**STAFF REPORT
KETCHUM PLANNING AND ZONING COMMISSION
SPECIAL MEETING OF APRIL 27, 2021**

- PROJECT:** Westcliff Townhomes
- FILE NUMBERS:** P21-019 & P21-008
- APPLICATION:** Design Review, Townhouse Subdivision Preliminary Plat, and Phased Development Agreement

- REPRESENTATIVES:** Peter & Kristin Anderson, Anderson Architecture, P.A. and Garth McClure, Benchmark Associates
- OWNER:** Westcliff LLC
- LOCATION:** 106 & 110 Rember Street (Bavarian Village Subdivision: Lot 3B)

BUILDING ELEVATIONS

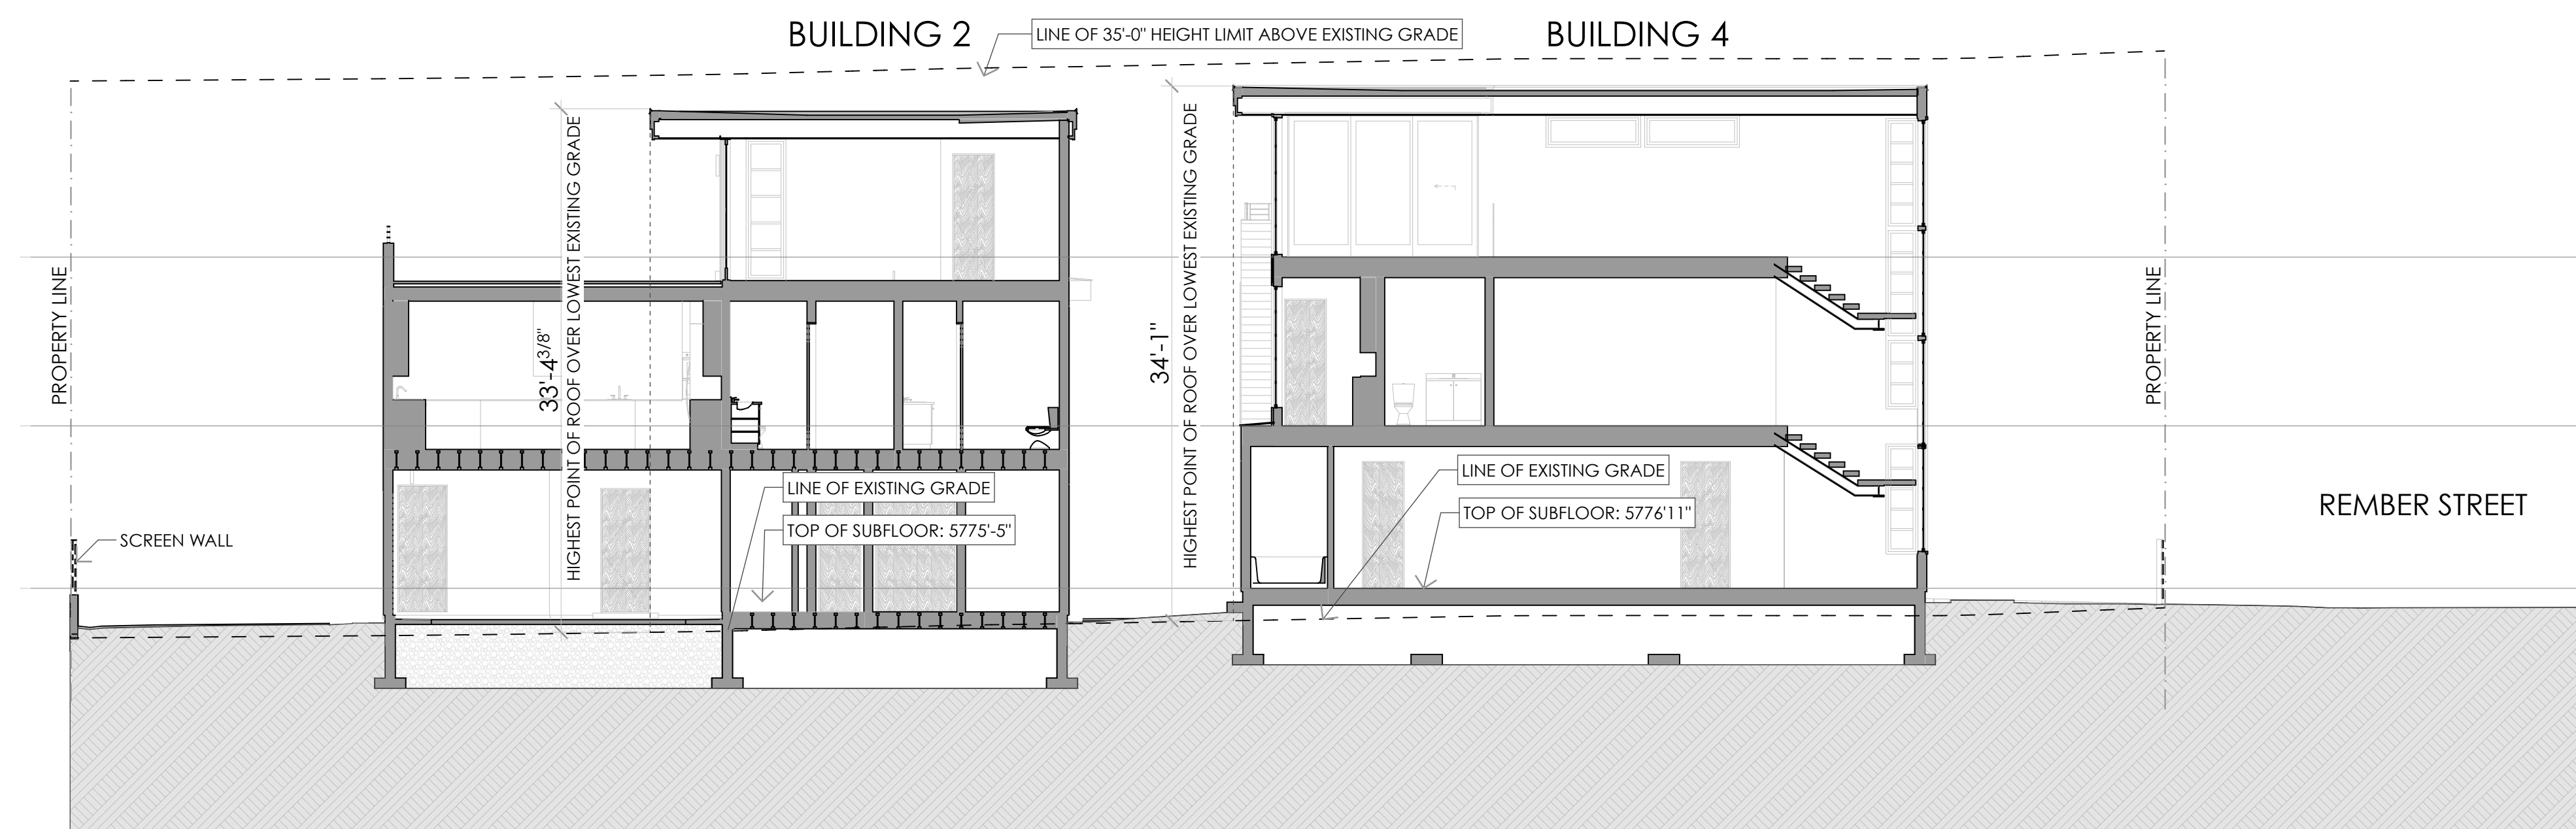
| | | | Staff Comments | The project's exterior materials include metal panels, stone veneer, and horizontal cedar siding. The exterior materials are specified on the elevations shown on Sheet A5 of the project plans. The specifications and colors for the project's proposed exterior materials are included on Sheet A8 of the project plans. All 4 townhome units share the same exterior material patterns and color palette. |

SECTION 1
SCALE: 1/8" = 1'-0" ①

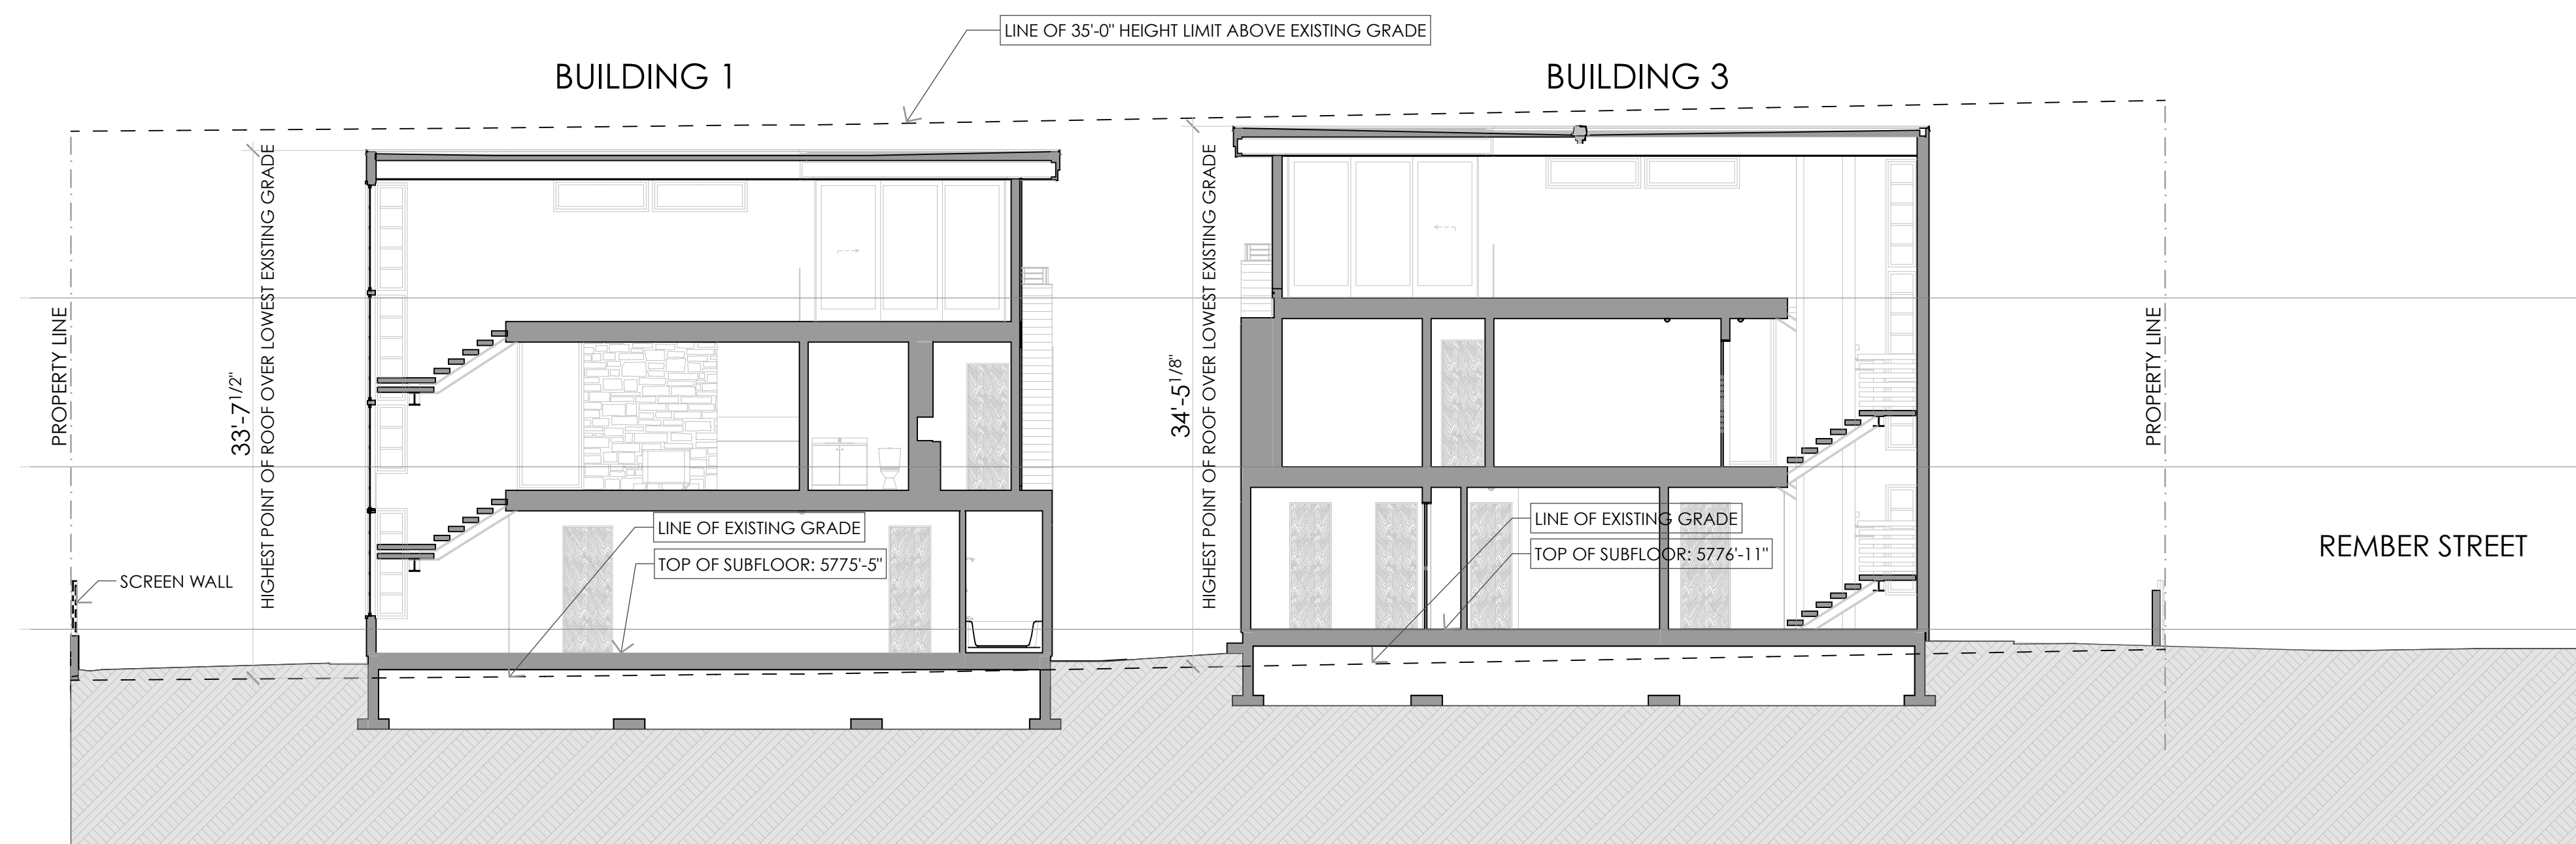
| | | | Staff Comments | <p>Maximum Permitted: 35 feet</p> <p>Proposed:</p> <p>The building sections on Sheet A7 of the project plans (Exhibit A) specify each townhome unit’s maximum height from the highest point of the roof to lowest grade. All townhome units are less than 35 feet in height from lowest existing grade.</p> <p>Townhome Unit Sublot 1: 33’-7”</p> <p>Townhome Unit Sublot 2: 33’-4”</p> <p>Townhome Unit Sublot 3: 34’-5”</p> <p>Townhome Unit Sublot 4: 34’-1”</p> |

GRADING PLAN
L-2.0

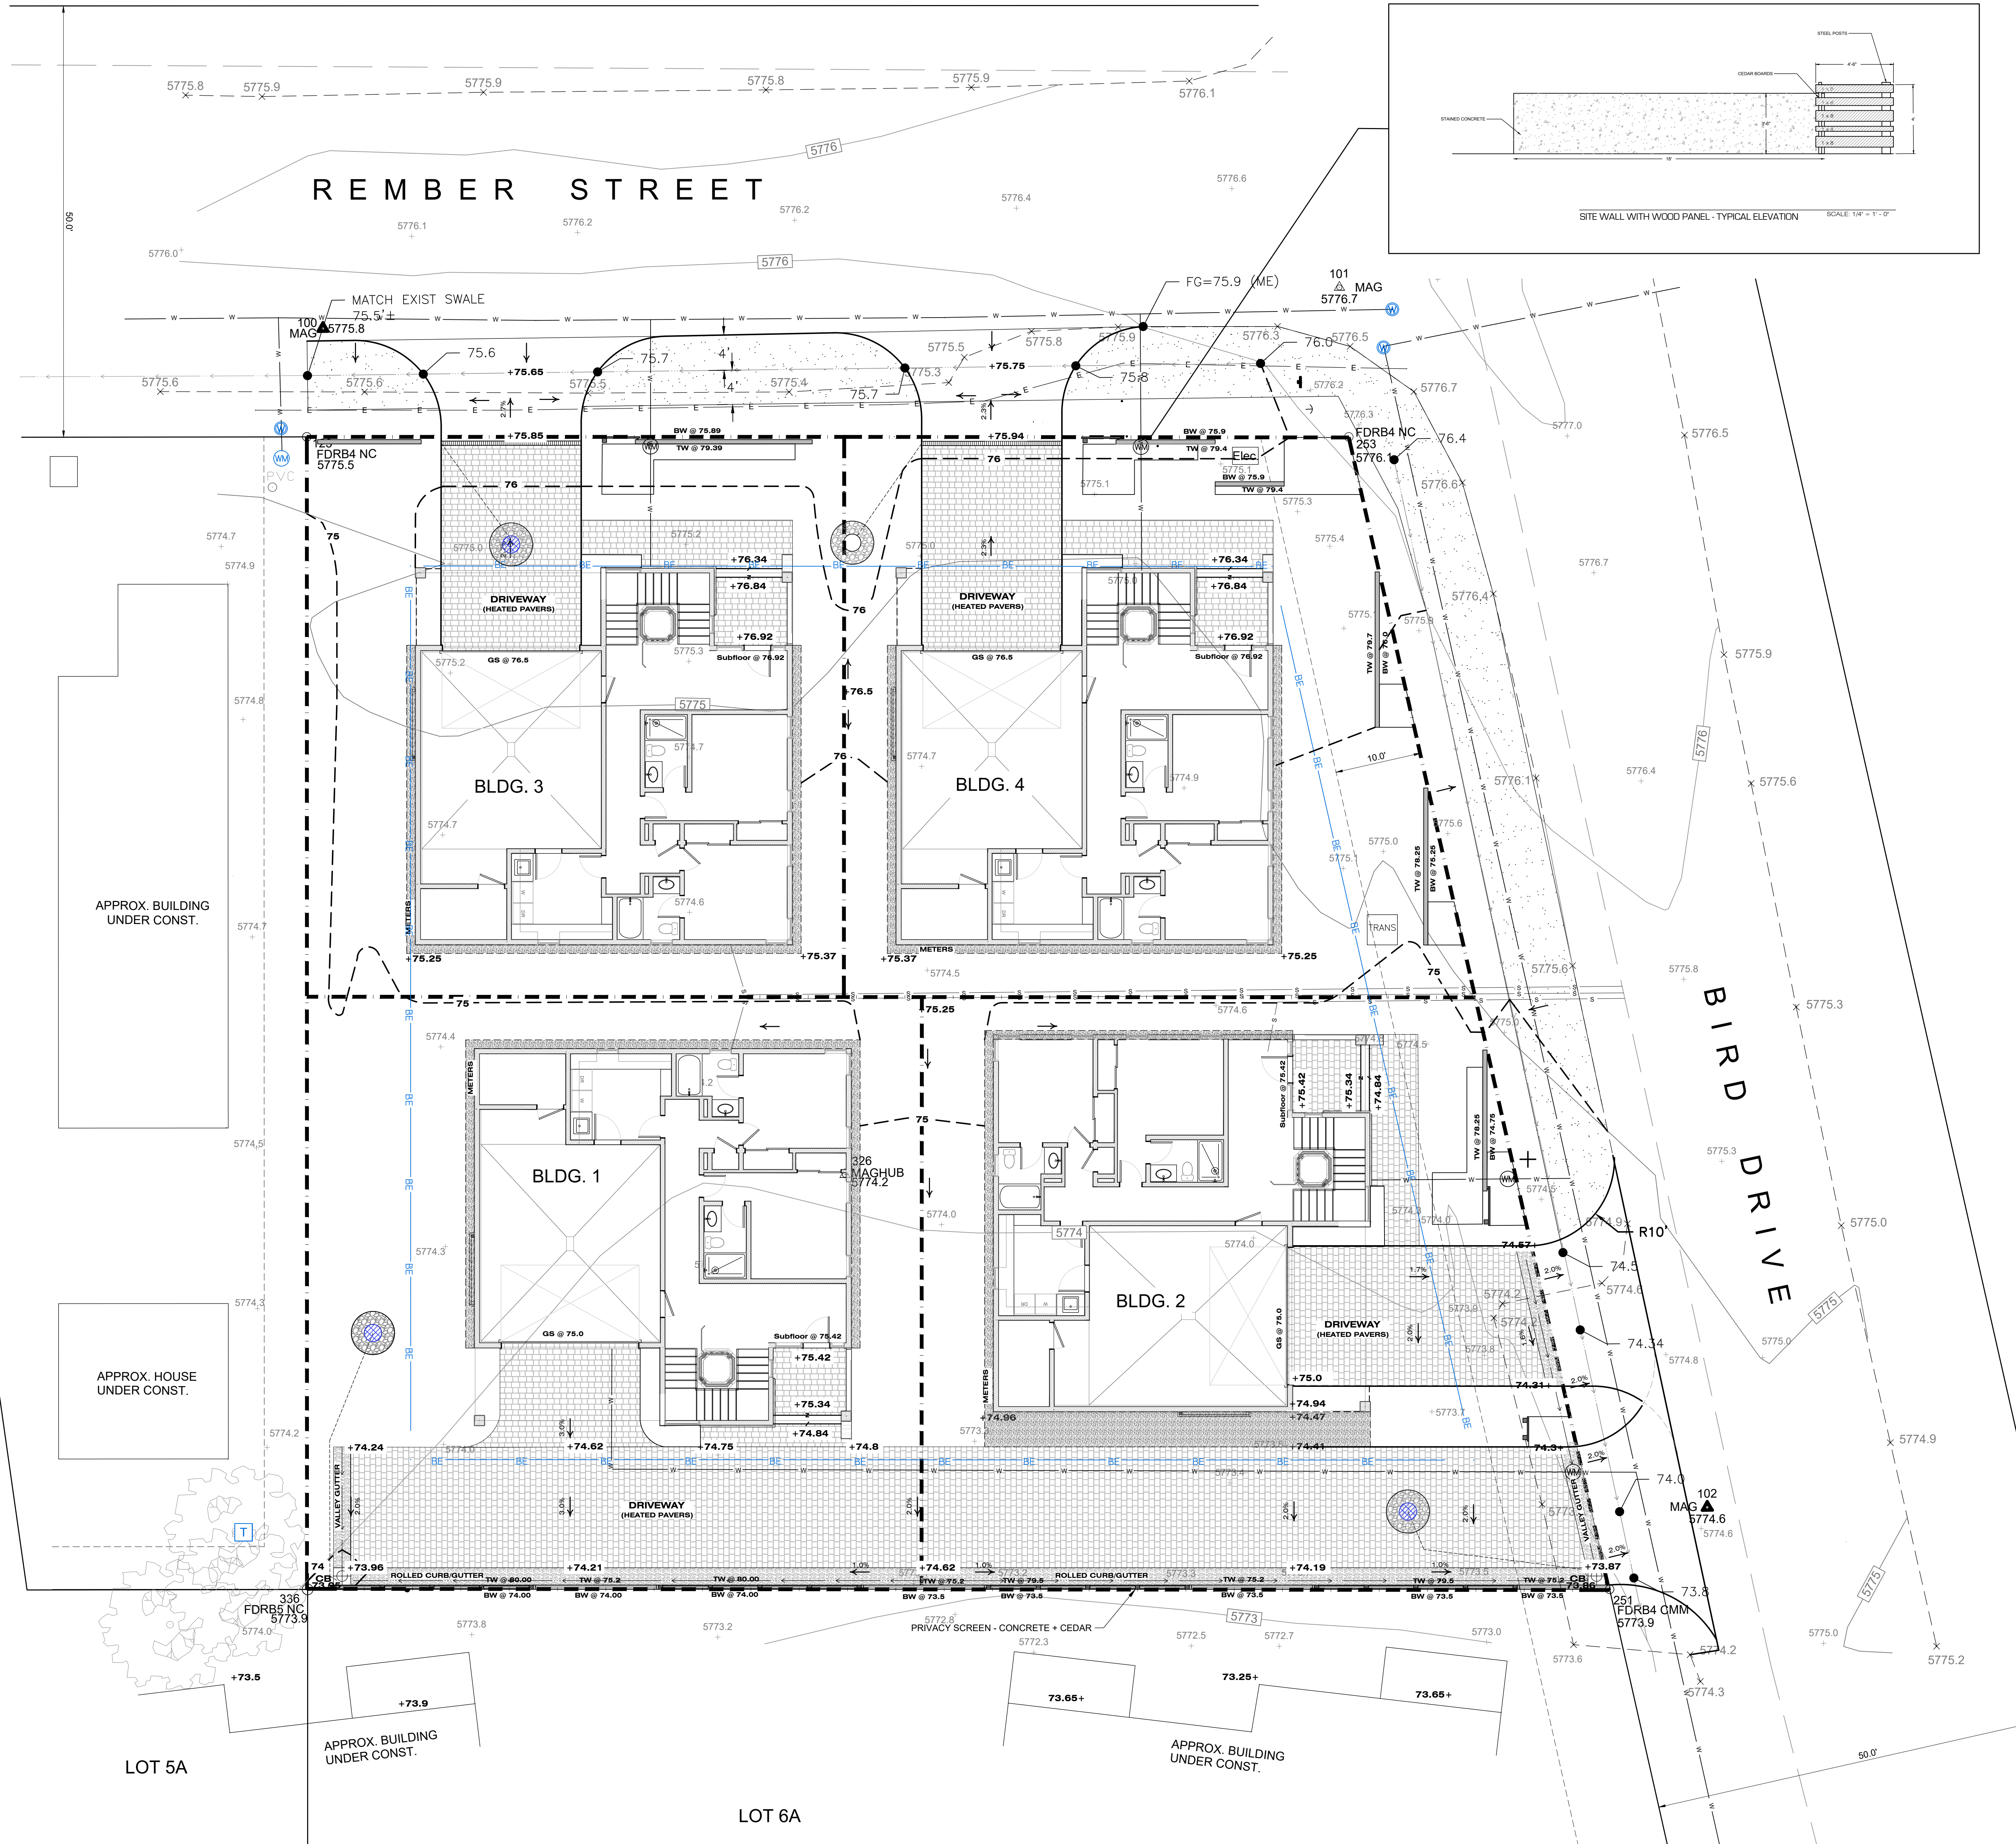
| | | | Staff Comments | As permitted by KMC §17.96.060.H4, the applicant has included a snowmelt system for all improved parking and pedestrian circulation areas instead of providing on-site snow storage areas. As indicated on Sheet L-2.0, the driveways, at-grade patios, and walkways are improved with heated pavers. |
